RAILTEL/TENDER/OT/CO/DNM/2017-18/Wi-Fi Gateways /391 Dated- 08.09.2017

#### Corrigendum\_-II

Sub: Request for proposals for "Supply and Supervision of Installation, Testing & Commissioning of Wi-Fi Gateways".

#### Annexure-I

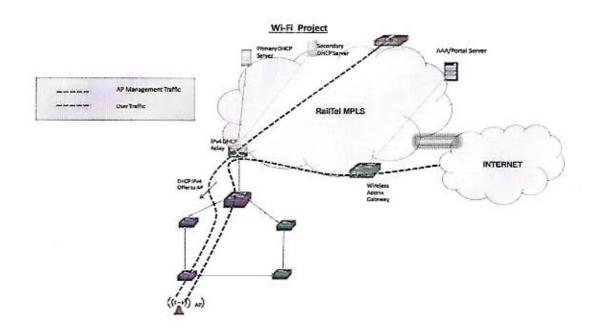
# 15. The Clause xxi (New Clause), under Chapter 3, Wireless access Gateway may be read as:-

The Gateway shall be support architecture and feature as per annexure-I.

For DHCP based IPoE sessions over a routed L3 network, the BNG can be set to act as a DHCP relay proxy or a DHCP local server. A DHCP relay agent forwards the DHCP request and reply packets between a DHCP client and a DHCP server. DHCP relay supports attachment of dynamic profiles and also interacts with the local AAA service framework to use back-end authentication servers.

The following steps describe, at a high level, how the subscriber will latch to the BNG

- A DHCP DISCOVER message is initiated by the subscriber.
- An intermediate device can either act as a relay agent and forward the DHCP request to the BNG acting as DHCP server or the BNG can act as the relay proxy and forward request to an external DHCP server

- The BNG will create a new subscriber session using the DHCP control packet
  arriving on its access interface based on client mac address extracted from the DHCP relay. This is
  unauthenticated session.

- 4. Access request is sent from BNG to AAA with Client MAC address
- If the Mac is unknown the request may be rejected and if known it will be accepted by AAA.

- Upon successful identity verification, AAA responds with Access Accept which includes the user profile and HTTP redirect service to be activated
- 7. The HTTP redirect that redirects the subscriber to Web Portal where subscriber can enter their credentials

- 8. Credentials are passed to the BNG using CoA which then sends them to AAA in access request
- 9. AAA should send access accept to authenticate the session

- 10. Now authenticated subscriber can access the internet
